Responses to comments posted by Referee #1

Responses to comments posted by Referee #2

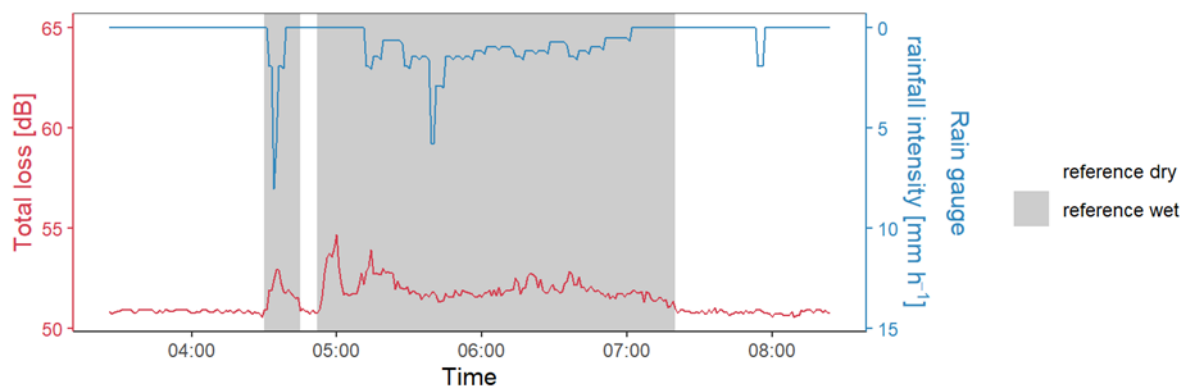
3. I agree with Referee 1's comment. At present, I do not understand why it is necessary to manually label dry or wet data when reference rainfall data is available. However, if this manual labeling is similar to using a simple constant threshold to divide dry and wet data, the so-called reference classification results will inevitably have significant errors. Please explain this issue.

First of all, we would like to clarify that dry-wet analysis is meant as a demonstration study illustrating the feasibility and the potential of a non-parametric model based on information theory. As such, it has limited representativeness. We have revised accordingly the introduction section on L77 - 78 where the analysis is first introduced. In the track-changes manuscript, we make this also clear in the abstract (L20 - 22) and conclusions (L583 - 586). In this context and given the available data (radar data were available only for selected events due to access restrictions), the semi-automatic classification involving visual inspection of CML data was a pragmatic solution.

The nearest rain gauge is located 3 km away from the CML, which is inadequate for capturing rainfall at a 1 min temporal resolution. We have therefore used this rain gauge for initial classification at hourly scale and refined the resolution by inspecting CML time series.

For the purpose of this response, we did an additional analysis testing the agreement of the rain gauge with our semi-automatic identification at the CML location. It shows overall agreement 97.1 %. However, focusing on the wet timesteps, the rain gauge indicates wet only in 50.8 % of wet timesteps at the CML location. The dry timesteps match at 98.6 %. Thus, manual fine-tuning is necessary to obtain a precise reference.

The plot below shows an example time series of the CML total loss and rainfall intensity from the closest tipping bucket rain gauge, with grey shading indicating our semi-automatically identified wet periods.

We add justification of the identification of the wet-dry periods to section 4.1.2. Detection of wet and dry timesteps – wet-dry classification analysis (L316 - 322).
